Product / Process Change Notification (PCN)

PCN #: PCN_UtFB_20210114

Affected Series: UtFB; 750310799

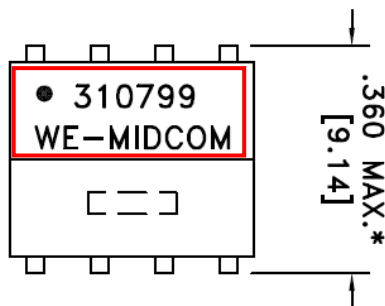
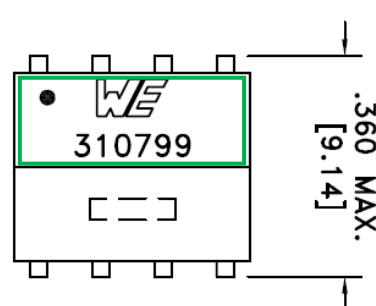
- The bobbin material will change from AM-113 to WH-9100
- The core tape material will change from 3M #1351-1 to Yahua CT-280
- The marking will change
